**ENVIRONMENTAL REVIEW COMMITTEE REPORT AND
ADMINISTRATIVE SITE DEVELOPMENT PLAN REPORT & DECISION**

ERC MEETING DATE:	October 13, 2014
Project Name:	Harper Engineering Parking Lot Addition
Owner:	Harper Engineering, 700 SW 7 th Street, Renton, WA 98055
Applicant/Contact:	Todd Schutz, Craft Architects, 2505 Third Avenue, Suite 324, Seattle, WA 98121
File Number:	LUA14-001199, ECF, SA-A
Project Manager:	Jill Ding, Senior Planner

GRADING/PAVING PLAN

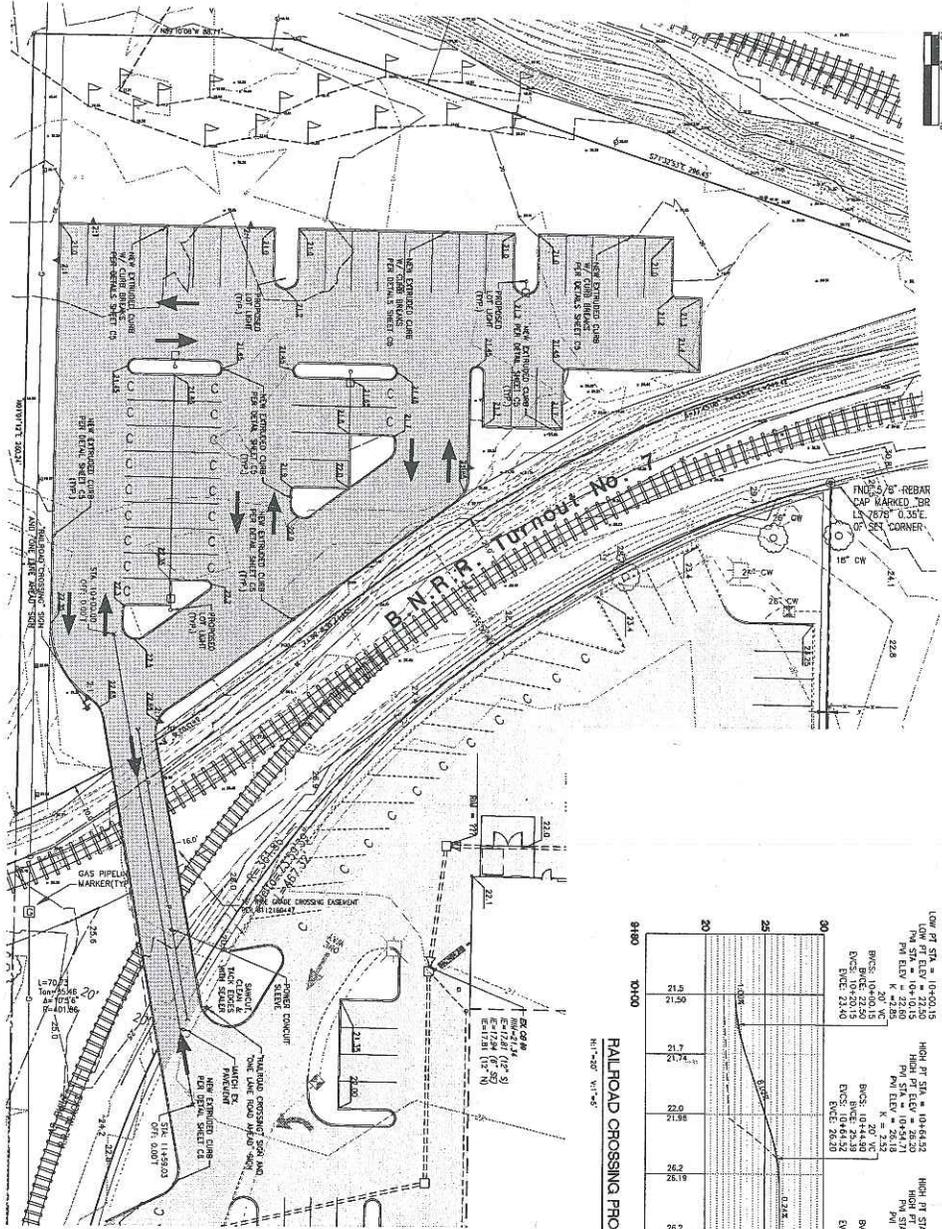
1. A fencing and signage detail around the Category 3 wetland buffer shall be submitted to the Current Planning Project Manager for review and approval prior to the issuance of the Construction Permit.
2. A revised site plan that shows compliance with the bicycle requirements outlined in RMC 4-4-080F.11 shall be submitted for review and approval by the Current Planning Project Manager prior to construction permit approval.
3. An analysis of employee trip impacts on traffic in AM as well as PM shall be submitted at the time of Construction Permit Review to the City's Plan Reviewer for review and approval.

LANDSCAPE PLANTING PLAN

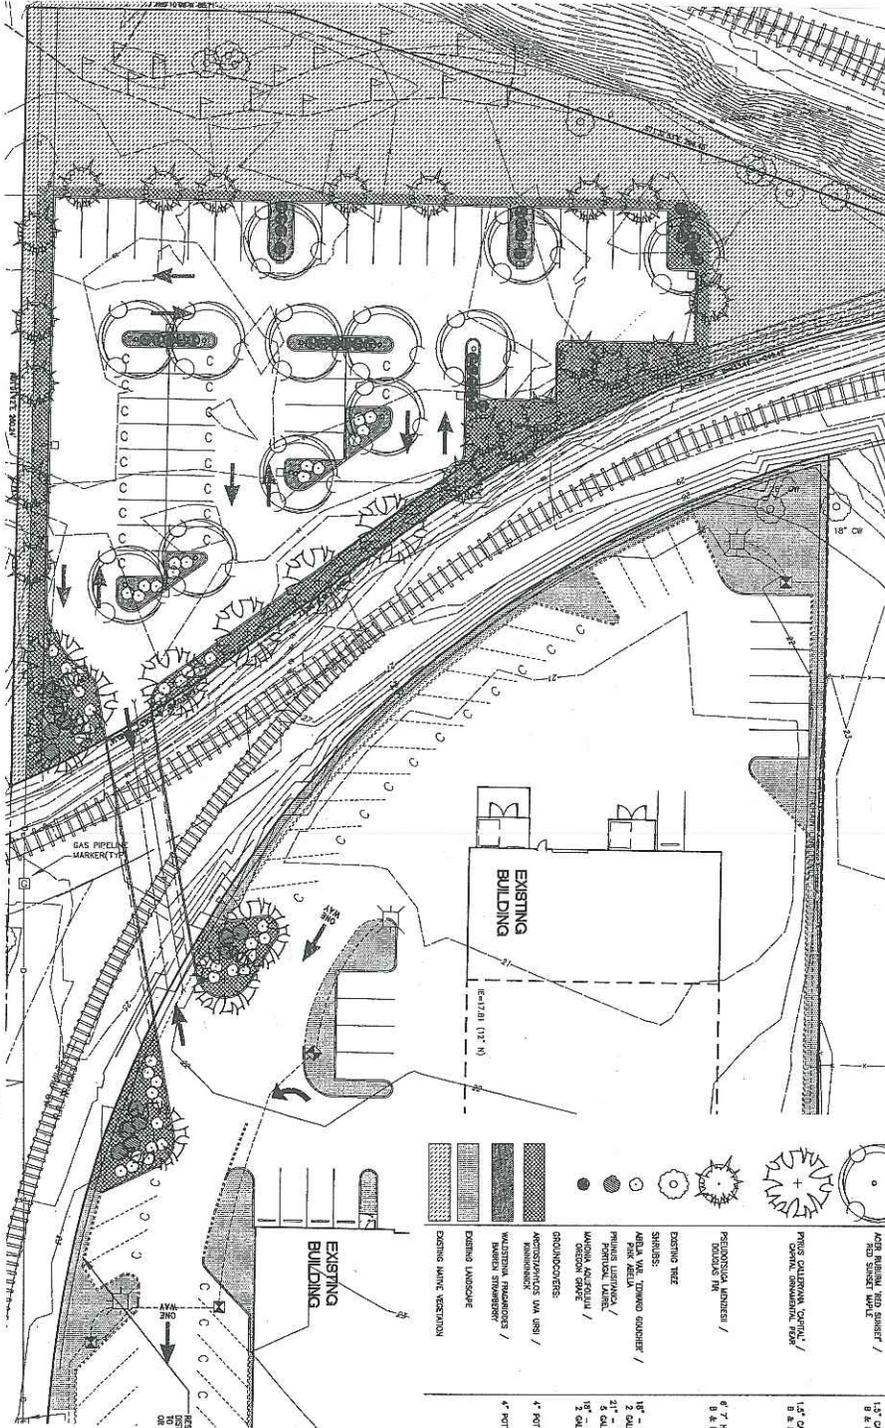
Staff Comment: A landscape plan was submitted with the application materials (Exhibit 3). The street frontage landscaping requirements are not applicable as the project site does not abut a public street frontage.

Based on the proposal to construct a new surface parking lot with 47 parking spaces, a total of 705 square feet of interior parking lot landscaping is required. The applicant is proposing a total of 1,200 square feet of interior parking lot landscaping and 4,600 square feet of perimeter landscaping. The proposed landscaping would exceed the minimum amount of landscaping required within the parking lot and would comply with this requirement.

Douglas Fir and Capital Ornamental Pear trees are proposed around the perimeter of the parking lot and Red Sunset Maple trees are proposed within the interior parking lot landscaping. The following shrubs are proposed within the interior parking lot landscaping: Pink Abelia, Portugal Laurel, and Oregon Grape. Kinnikinnik is proposed to be planted around the perimeter of the parking lot and Barren Strawberry would be planted within the interior landscaped areas. The proposed plantings would comply with the minimum requirements outlined in the City's Landscaping Regulations.

EXISTING TREE RETENTION PLAN HARPER ENGINEERING ADDITION PHASE 2 SW 1/4 SECTION 18, TWP. 28 N., RGE. 5 E., W4.

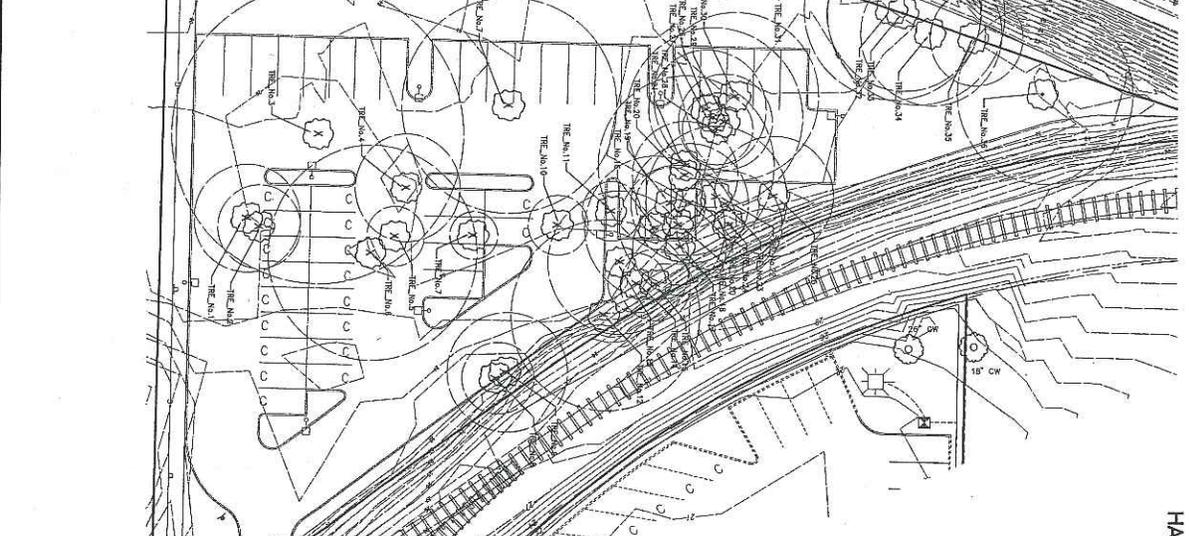
Of the existing 39 significant trees which have been identified, 9 are proposed for retention. The City's adopted Tree Retention regulations (RMC 4-4-130) require the retention of 5 percent of the trees on site. The proposal to retain 9 existing trees results in a retention rate of 23 percent, which exceeds the minimum tree retention requirements.

LANDSCAPE IRRIGATION PLAN
DATE: 09/11/2014
SCALE: 1/8" = 1'-0"

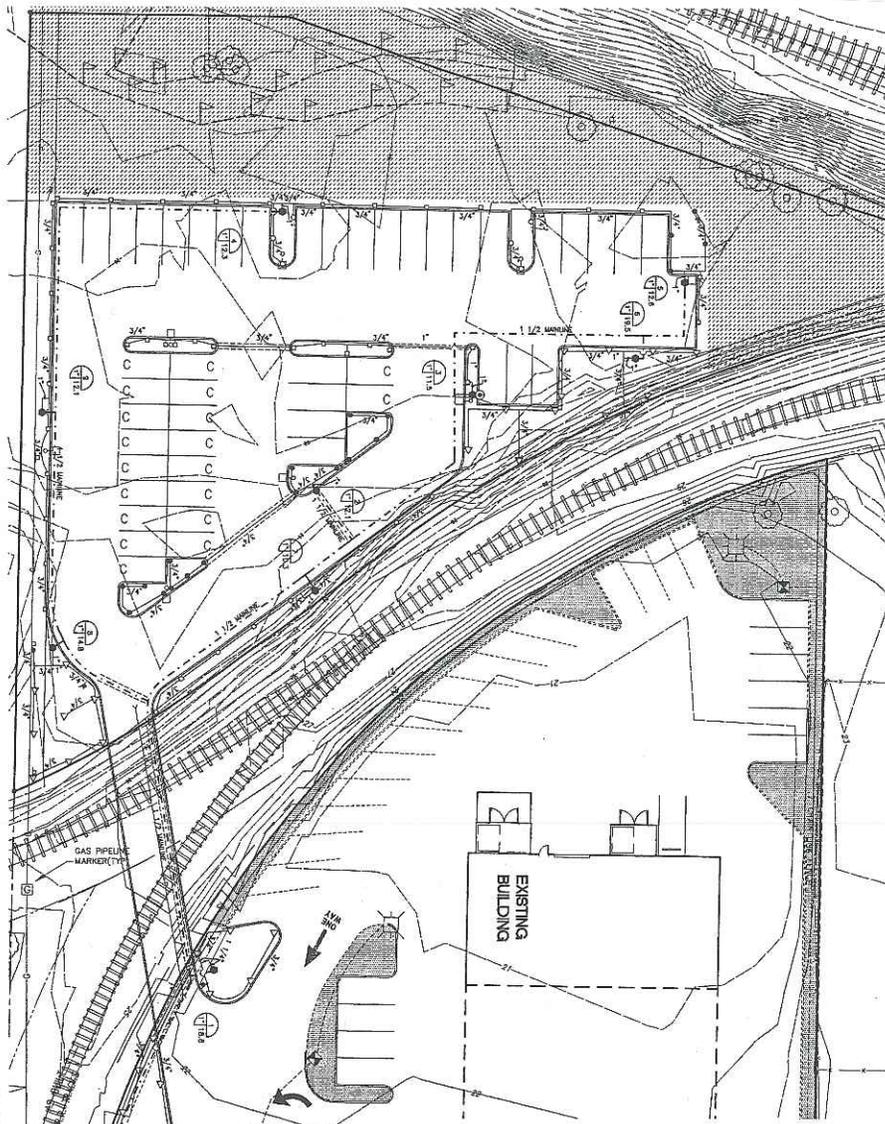
An Irrigation Plan was submitted with the application materials (Exhibit 10). Underground sprinkler systems are required to be installed and maintained for all landscaped areas. The sprinkler system shall provide full water coverage of the planted areas specified on the landscape plan (Exhibit 3).

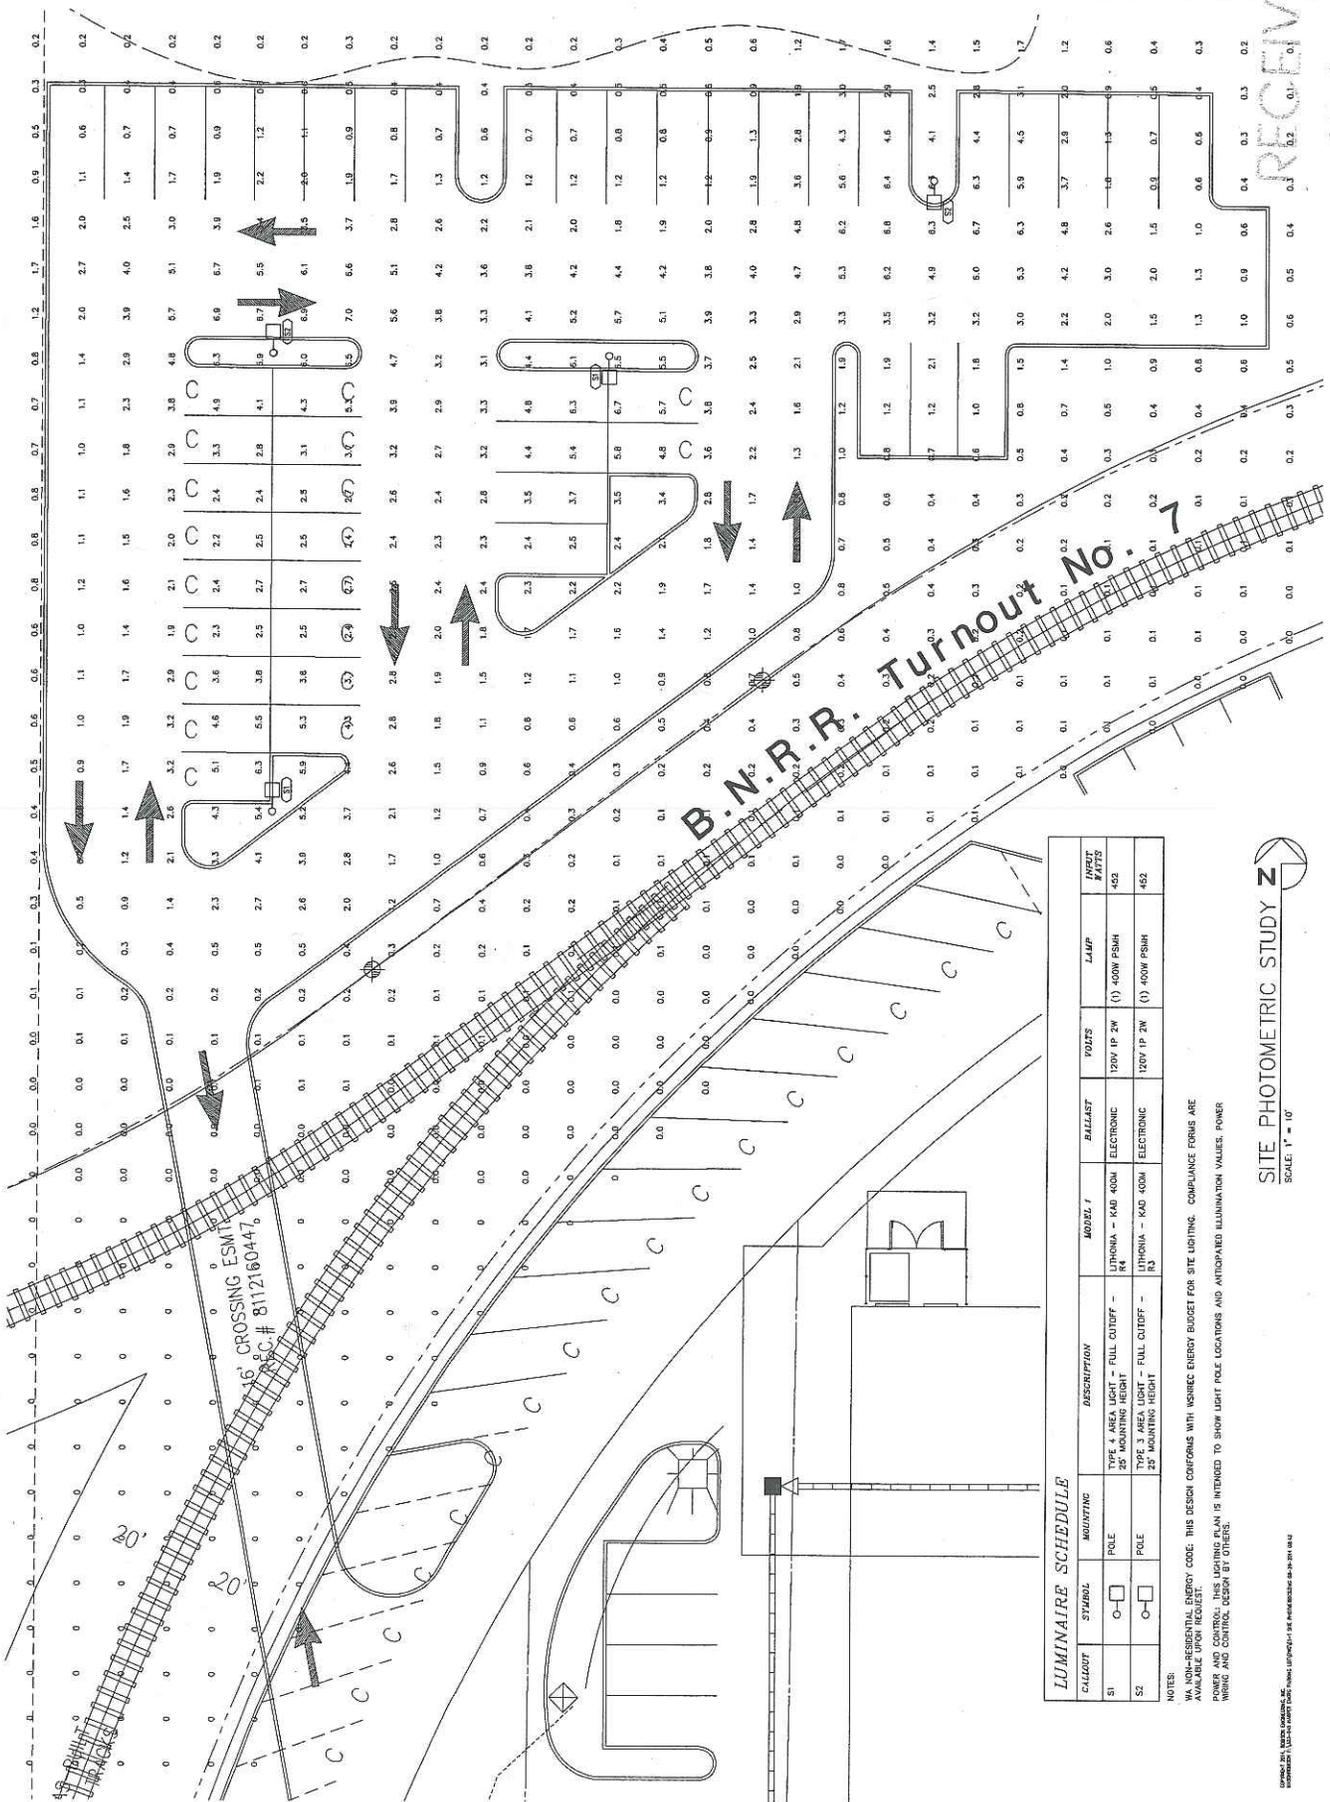
A lighting plan (Exhibit 11) was provided with the project materials. The proposed light fixtures would

have a maximum height of 25 feet and be fitted with full cutoff luminaires, which would adequately provide for public safety without casting excessive glare on adjacent properties. The proposed parking lot lighting would comply with this requirement.
